SUBJECT: WASTEWATER PILOT PLANT RD&D PERMIT

The attached information addresses the questions and/or comments included in the telefax you sent to Mr. Cliff Clark, Department of Energy - Richland Field Office on February 19, 1993.

To: D. L. Flyckt
From: D. E. Scully
Subj: Responses to EPA's 2/19/93 FAX

Figure 4-1. Waste Water Pilot Plant Floor Plan.

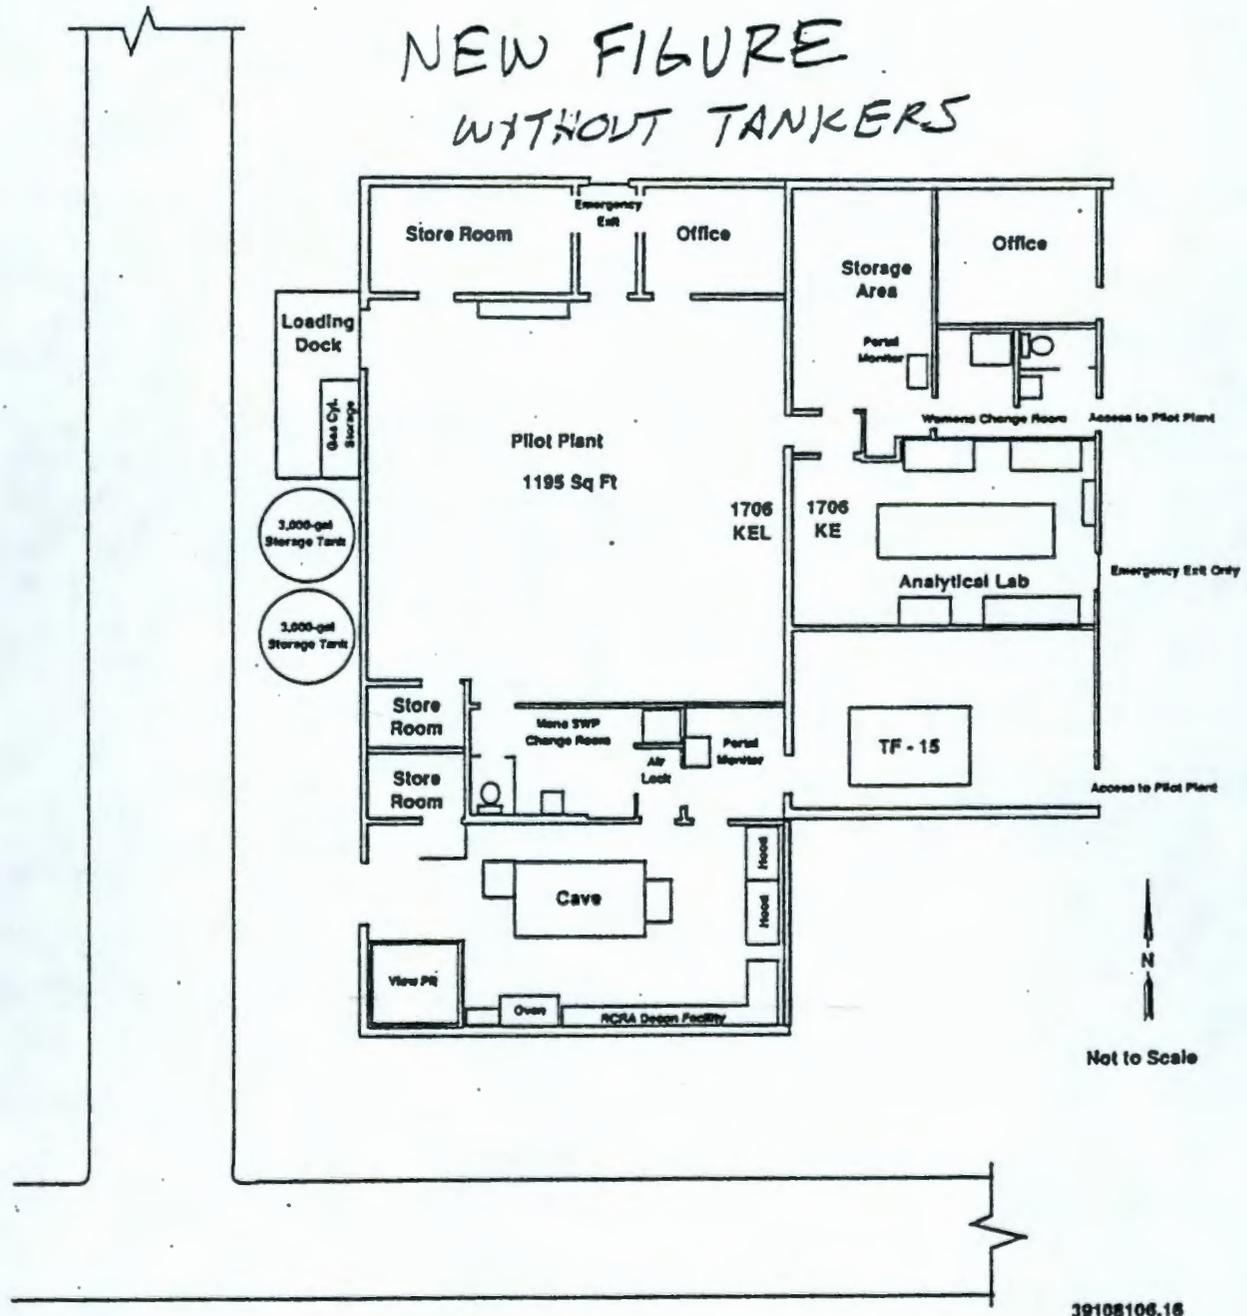
Attachment 2 addresses the fifth bullet, identified as *Figures 4-1 through 4-24 (Comments 36, 36)*. Included is the new Figure F4-1 showing the Waste Water Pilot Plant Floor Plan without tankers; the new Figure F4-23 showing the Waste Load/Unload Station at the 1706-KE Building; Figure F4-24 showing the Tank Trailer Configuration for Unloading at the 1706-KE Building (replaces Figure 4-23 in Rev. 1); Figure F4-25 showing the Tank Trailer Configuration for Loading at the 1706-KE Building (replaces Figure 4-24 in Rev. 1); and a new figure, F4-26, the Portable Berm Foundation Cross-Section.

NEW FIGURE WITHOUT TANKERS

Figure 4-23. Waste Load/Unload Station at the 1706-KE Building.

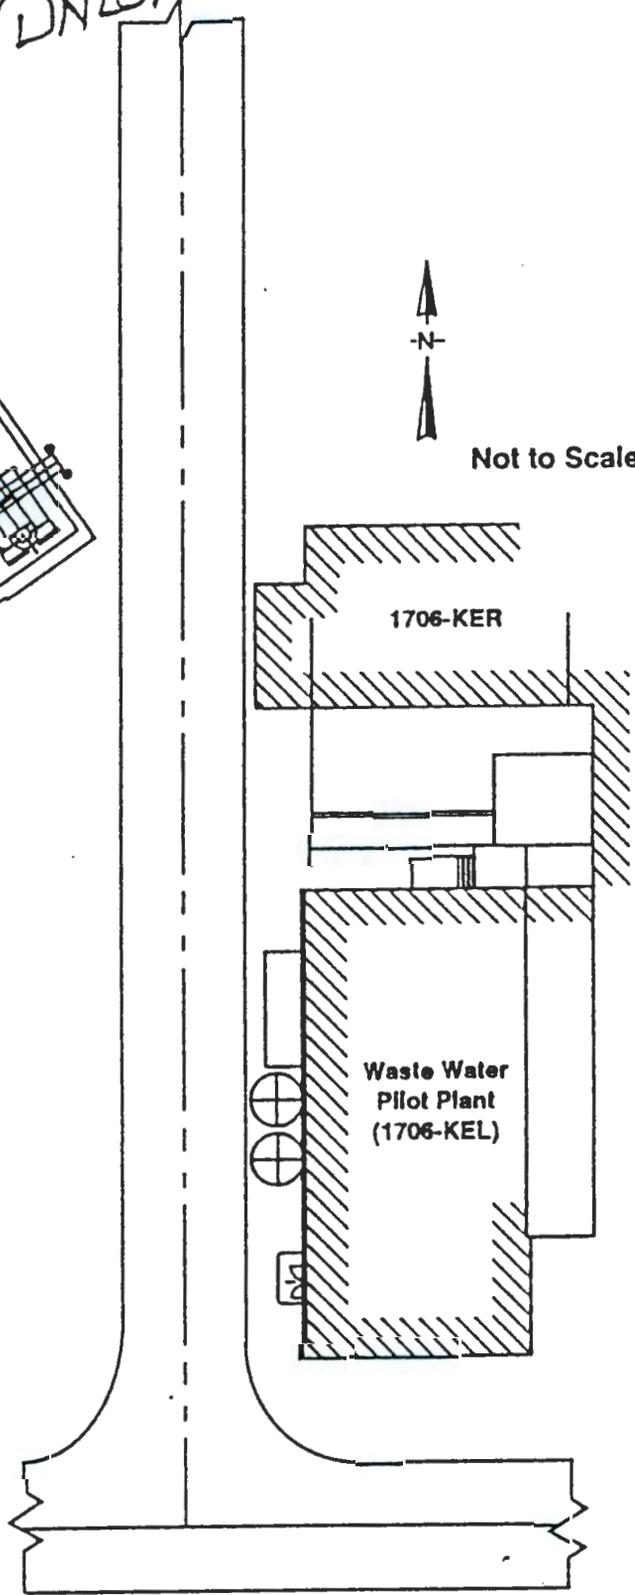
SHOWS LOAD/UNLOAD AREA

Figure 4-24. Tank Trailer Configuration for Unloading at the 1706-KE Building.

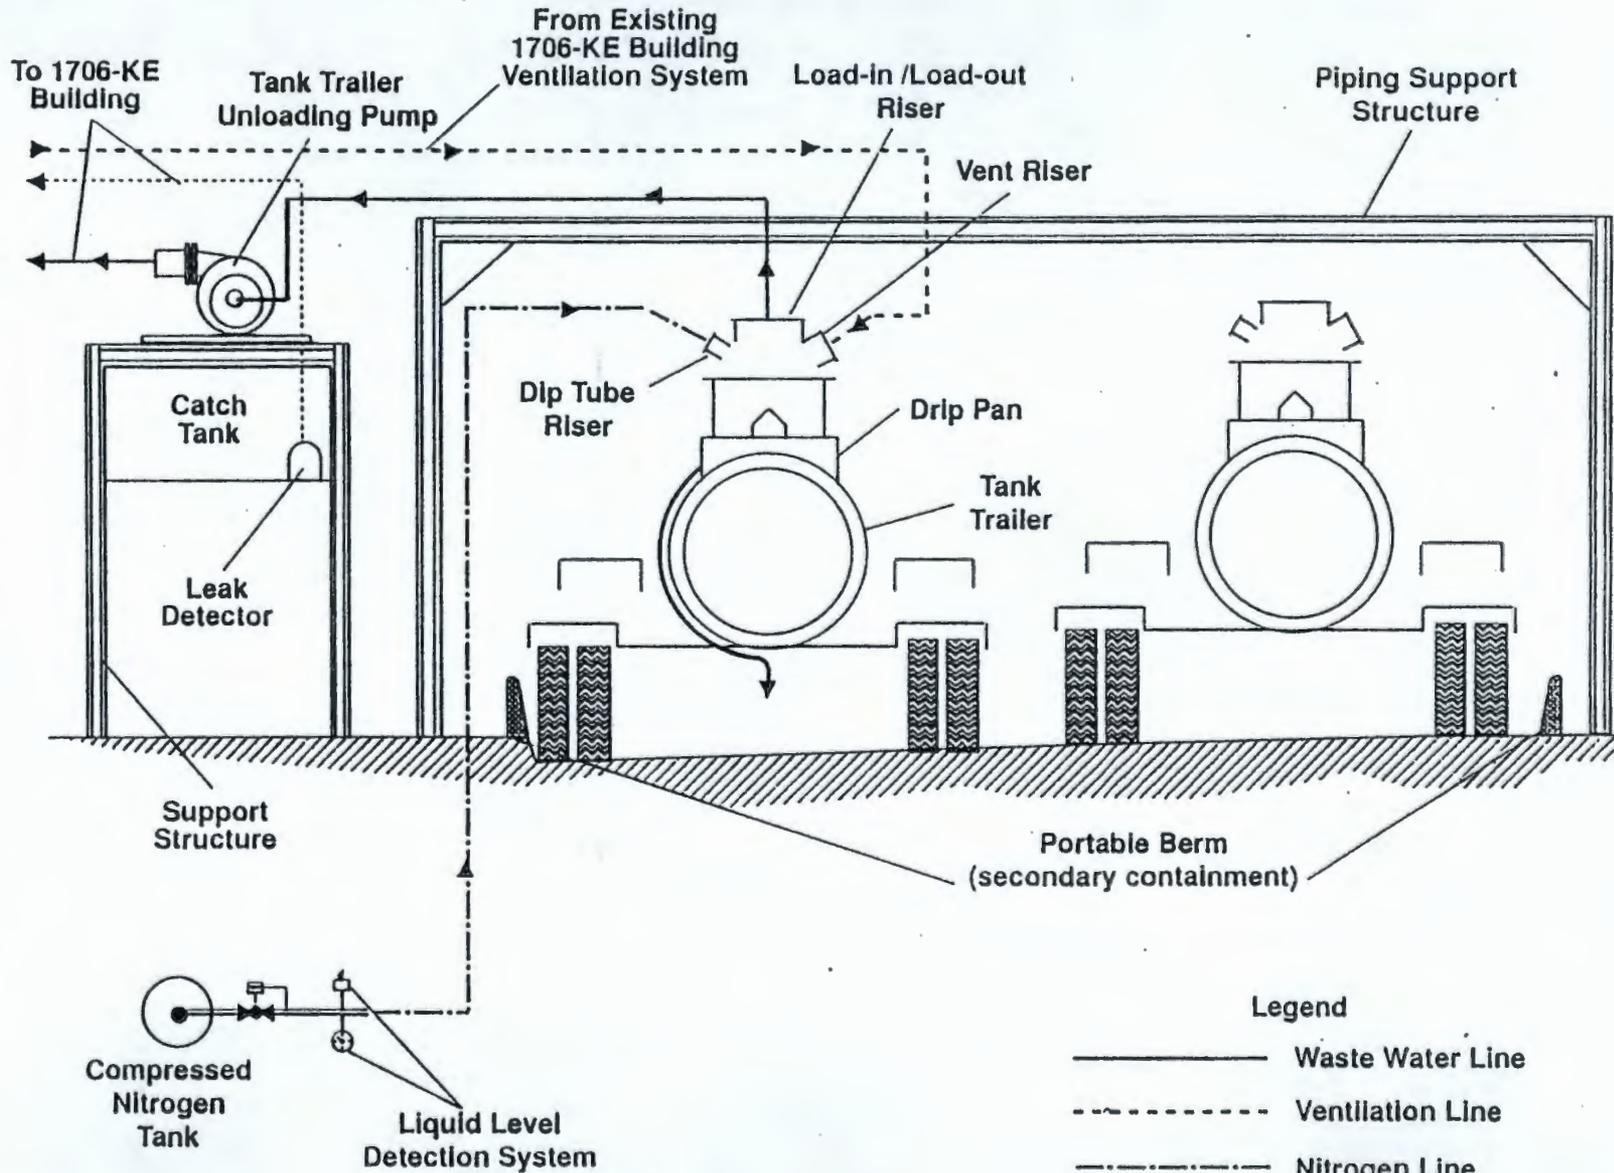
NEW FIGURE
REPLACES 4-23
IN REV 1

Figure 4-25. Tank Trailer Configuration for Loading at the 1706-KE Building.

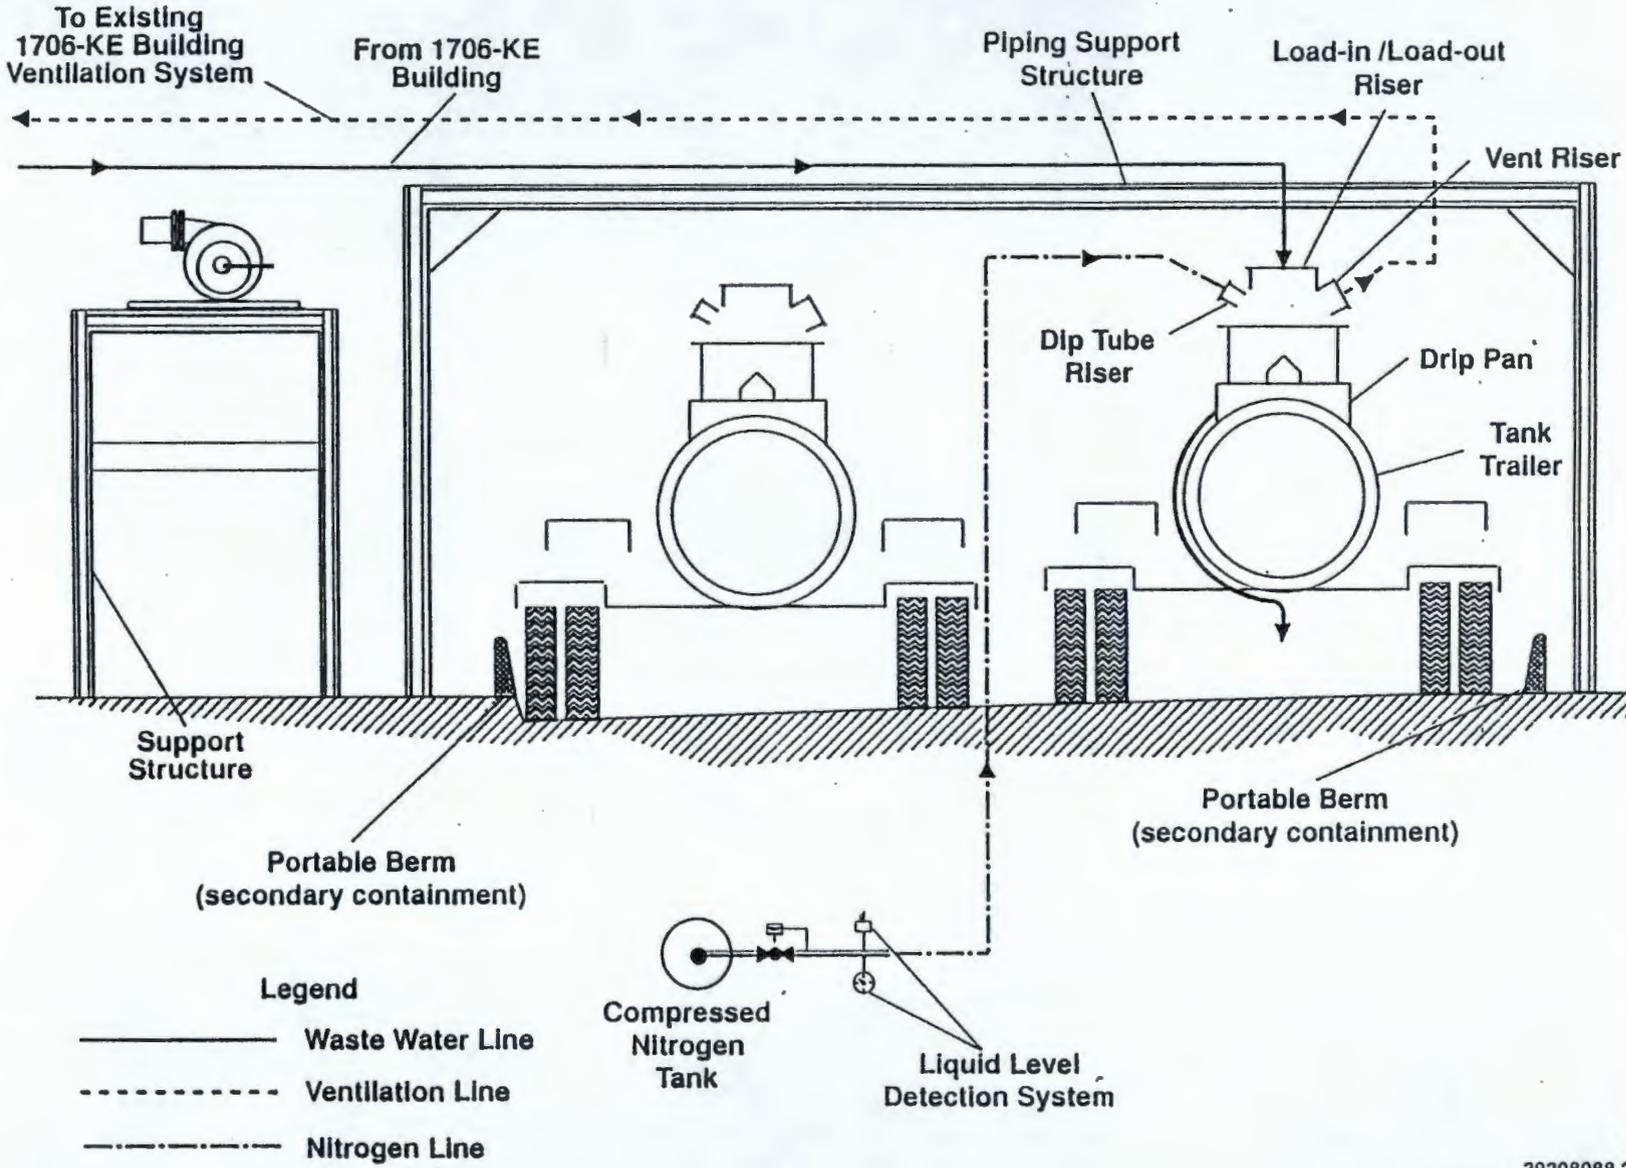
NEW FIGURES
 REPLACES 4-24 IN REV 1
 DOE/RL-91-39
 REV. 1A
 12/18/92

Figure 4-26. Portable Berm Foundation Cross-Section.

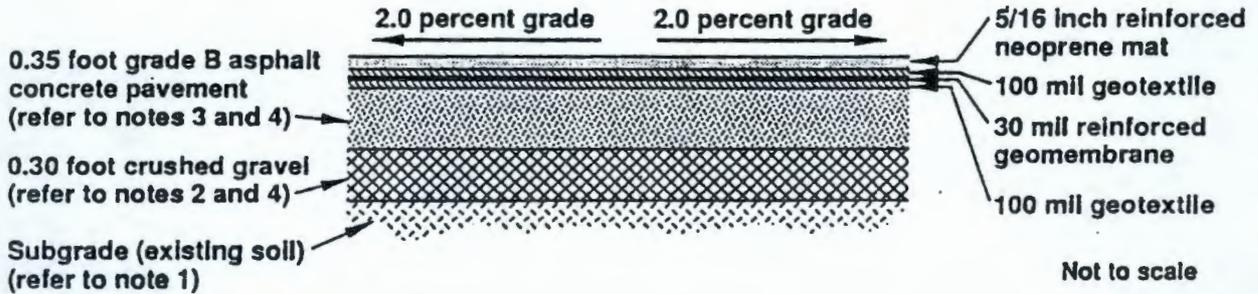
NEW FIGURE
